Errata to IEEE Standard for Higher Performance Protocol for the Standard Digital Interface for Programmable Instrumentation

Correction Sheet
Issued 17 November 2004

Figure 5—AH state diagram

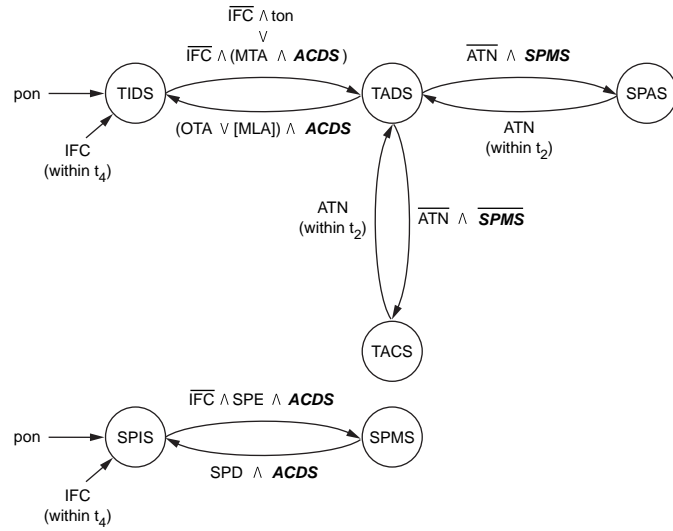
Page 24, **Figure 5—AH state diagram** is incorrect; it should be replaced with the following:
